APPLICATION NO.	FILING DATE	FIRST NAMED INVENTOR	ATTORNEY DOCKET NO.	CONFIRMATION NO.
10/823,896	04/14/2004	James E. Masseth JR.	89843.048703	5665

Office Action Summary

DETAILED ACTION

FIG. 4

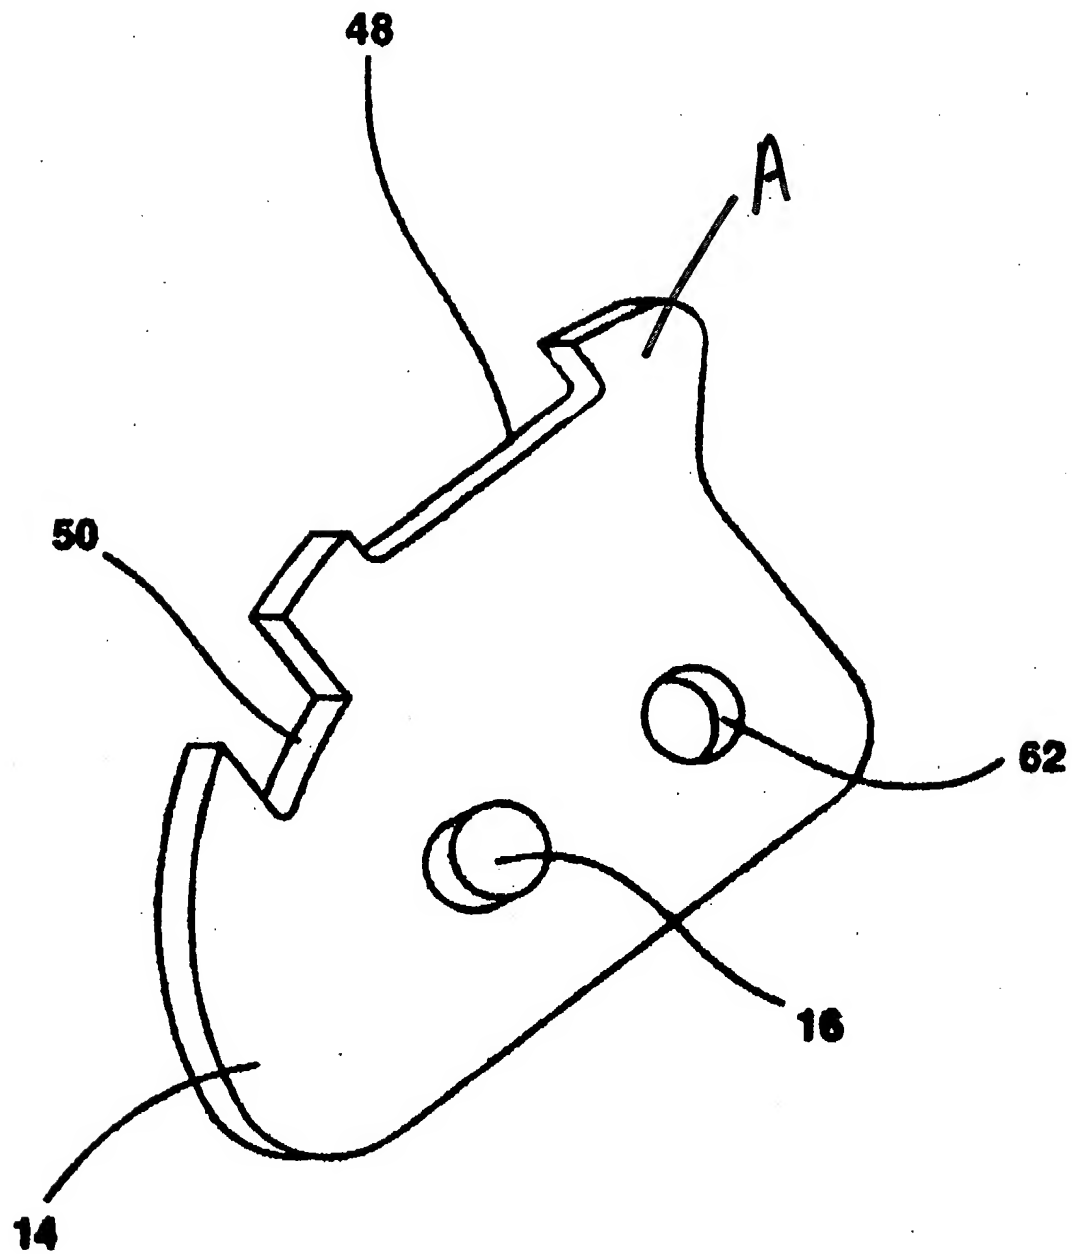
In regard to claim 11, Suggs discloses a locking mechanism further comprising a tail (A, See Examiner's Attachment) piece coupled with the second plate and being associated with the tumbler stack to selectively allow the second plate to move to the unlocked position.

In regard to claim 21, Suggs discloses a locking mechanism further comprising a tail (A, See Examiner's Attachment) piece coupled with the primary lock plate and associated with the tumbler stack to selectively allow the primary lock plate to move to the unlocked position.
